STATE OF NORTH CAROLINA
DEPARTMENT OF TRANSPORTATION

Subject: **Modification Request for Individual Section 404 Permit and Section 401 Certification for Section R-2707B** of the US 74 Shelby Bypass in Cleveland County. Federal Aid Project No. NHF-74(14), State Project No. 8.1801001, WBS Number 34497.1.2, Division 12, TIP R-2707. Debit \$570 from WBS Number 34497.1.2

CLEVELAND COUNTY
(R-2707B)

REPLACES PERMIT DRAWING SHEET 4 OF 30
 REVISED JUNE 27, 2013
 -DRIVE 3 - STA 13+75.0
 NOTE: TIE TO EXISTING
 FOR -END POINT FROM SHEET NO. 16

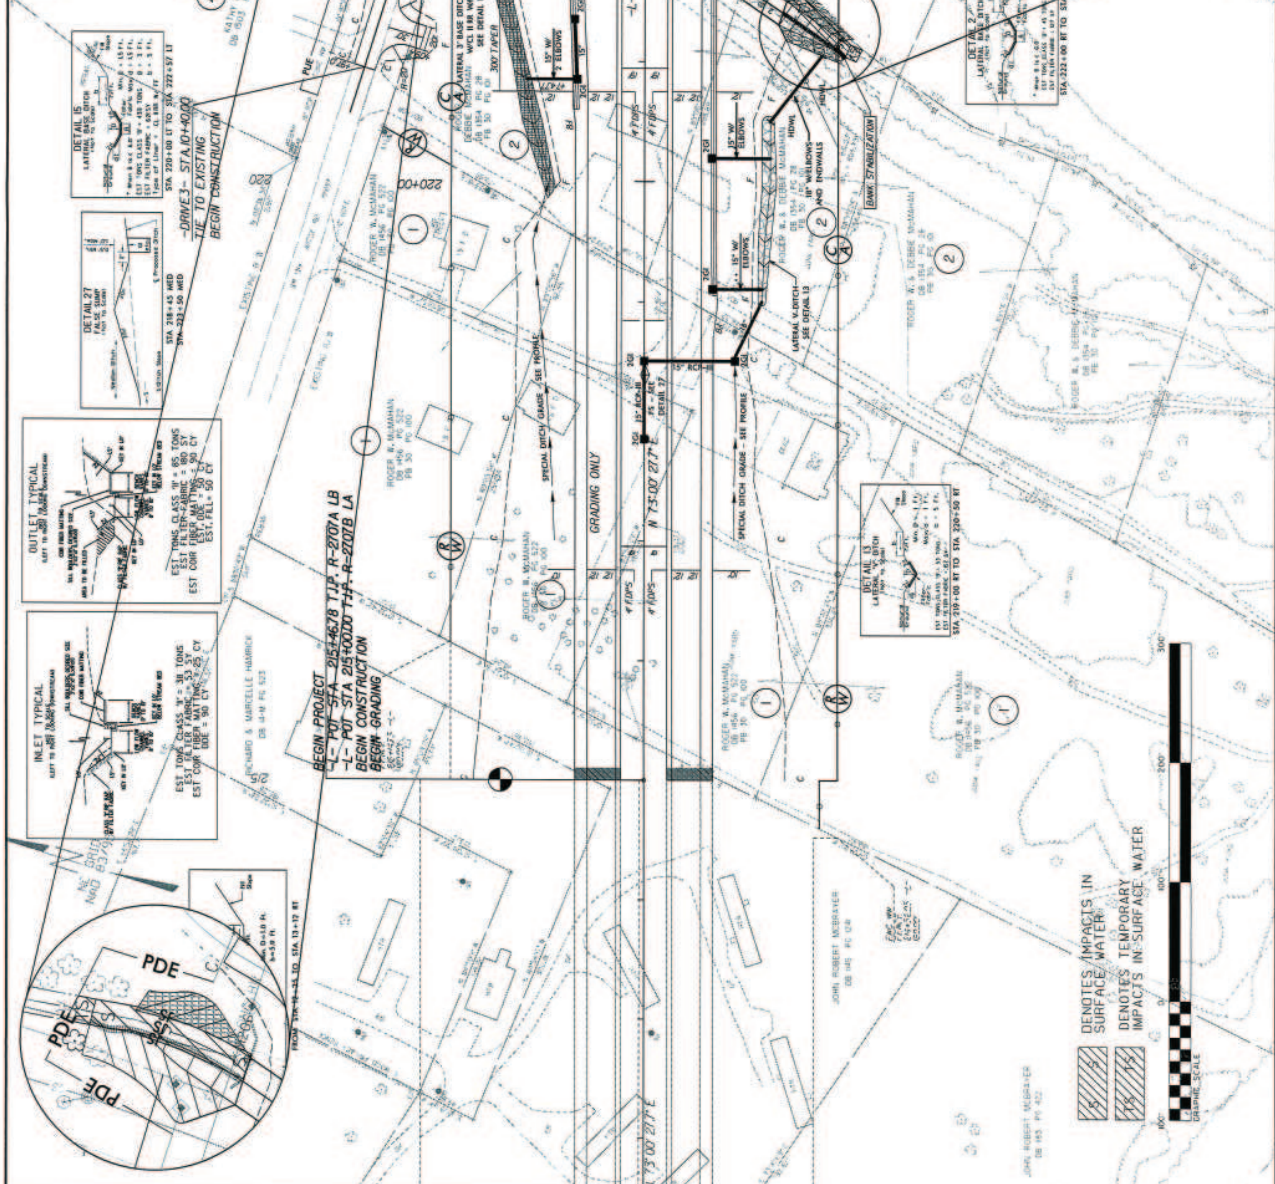
This letter addresses modifications to Section R-2707B of the proposed US 74 Shelby Bypass that extends from west of SR 1314 (Artee Road) to west of NC 226 in Cleveland County. The North Carolina Department of Transportation (NCDOT) requests approval for revisions to the above referenced permits. NCDOT proposes to extend a culvert to construct a driveway to provide a landowner access to property that was proposed to be cut off in the original permit application (R-2707B Permit Site 1). When the project was originally sent out for Right of Way acquisition, NCDOT believed the north side of Artee Road at Permit Site 1 was owned by one property owner. During the acquisition process, it was discovered that there were three parcels with three property owners and one (Parcel 30) would be cut off by the proposed dead ending of Artee Road to the west of Permit Site 1. In order to provide access to parcel 30, NCDOT had to maintain more of the existing Artee Road alignment and extend the culvert at Permit Site 1 to provide the driveway connection.

The original impacts for R-2707B Permit Site 1 from the July 9, 2012 permit application were 397 linear feet of permanent impacts to surface waters with 11 linear feet of bank stabilization. This modification changes the impacts at R-2707B Permit Site 1 to 388 linear feet of permanent impacts to surface waters with 80 linear feet of bank stabilization. The permanent impacts to surface water are roughly the same because the culvert extension is an area that was already being impacted by the relocation of the stream (UT to Beaverdam Creek) into a new channel upstream of the originally proposed culvert. The bank stabilization has increased to transition the angle of the stream alignment into the floodplain bench on the right barrel of the culvert inlet. The

additional **60** linear feet of bank stabilization will not need mitigation as it is covered in the 3,535 feet of mitigation secured at a 2:1 rate for the Army Corps of Engineers from the NCEEP on July 3, 2013. The revised total stream impacts for R-2707B are 3,680 linear feet. Wetland impacts on this section will not change.
